TVGA CONSULTANTS
☐ NO EXCEPTIONS TAKEN ☐ REJECTED
☒ FURNISH AS CORRECTED
☐ REVISE AND RESUBMIT
ENGINEER has reviewed Shop Drawings and Samples and other data which Contractor is required to submit, only for conformance with the information given in the Contract Documents and compatibility with the design concept of the completed Project as a functioning whole as indicated in the Contract Documents. Such reviews do not extend to means, methods, techniques, sequences or procedures of construction or to safety precautions and programs incident thereto. Such reviews do not extend to any LEED certification or accreditation. Contractor is responsible for dimensions to be confirmed and correlated at the job site, for information that pertains solely to the fabrication processes or to techniques of construction, and for coordination of the work of all trades.
BY: JLM
DATE: 11-05-09

DESCRIPTION: GIRDER - 218G2E

STRUCTURE:	RAMP D VT RTE 279 OVER WALLOOMSAC RIVER BRIDGE NO. B15N BENNINGTON COUNTY	DRAWN: WR	DATE: 07/13
		CHKD: DO	DATE: 08/17
LOCATION:	BENNINGTON, VERMONT	JOB NO.	DWG NO.
PROJ NO.	AC NH 019-1(51)	408-2	218
CUSTOMER:	KUBRICKY CONSTRUCTION		REV. △

ONE - GIRDER - 218G2E (DEV.)

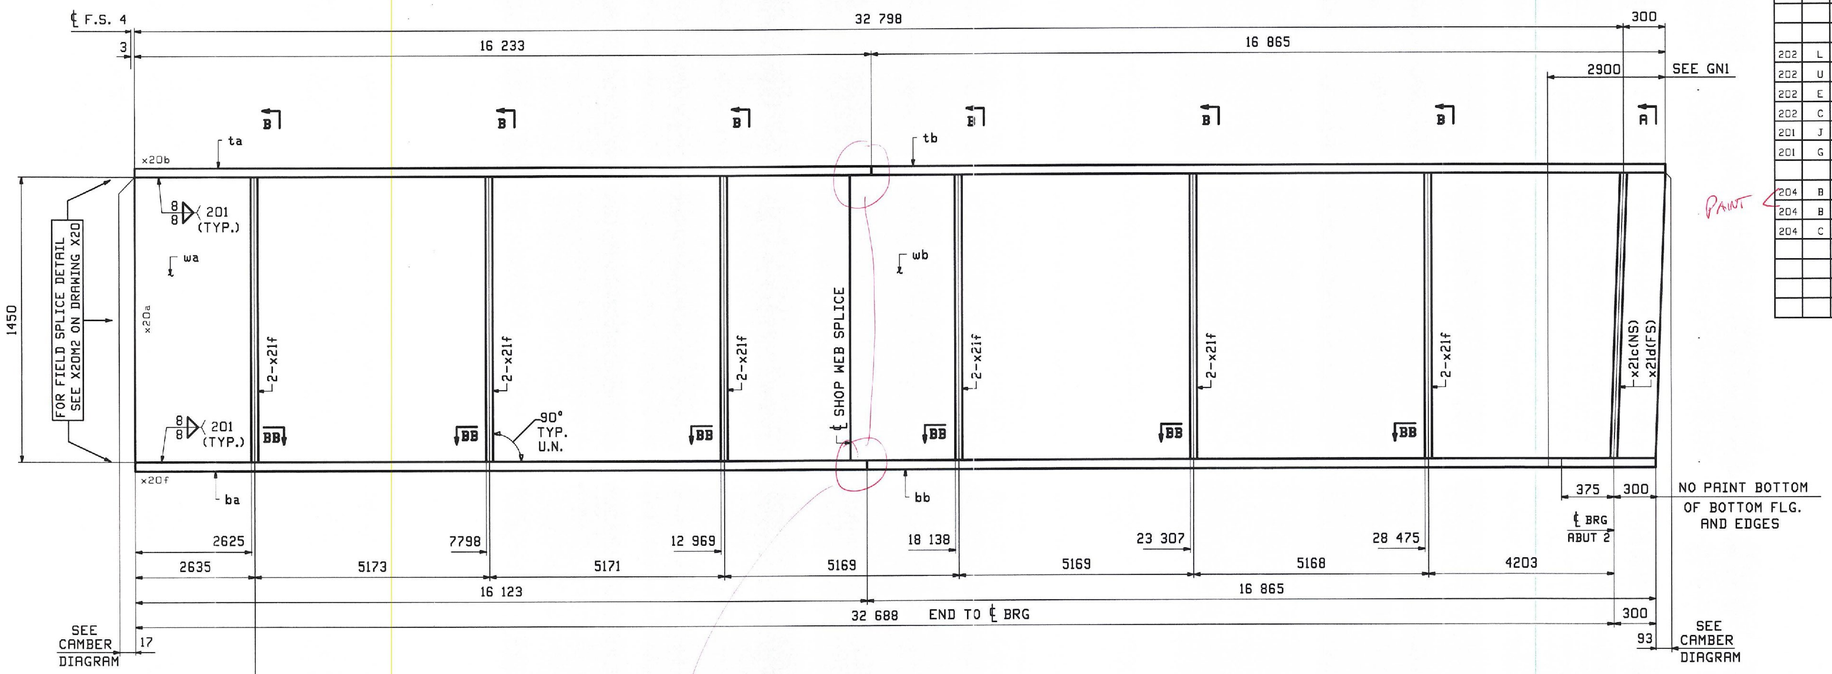
Per Drawing BR 287 "Girder Elevation (Ramp D)" and VTRans Structures Design Manual Section 20.6; "Shop flange butt welds and Shop web butt welds shall preferably have a 600 mm offset".
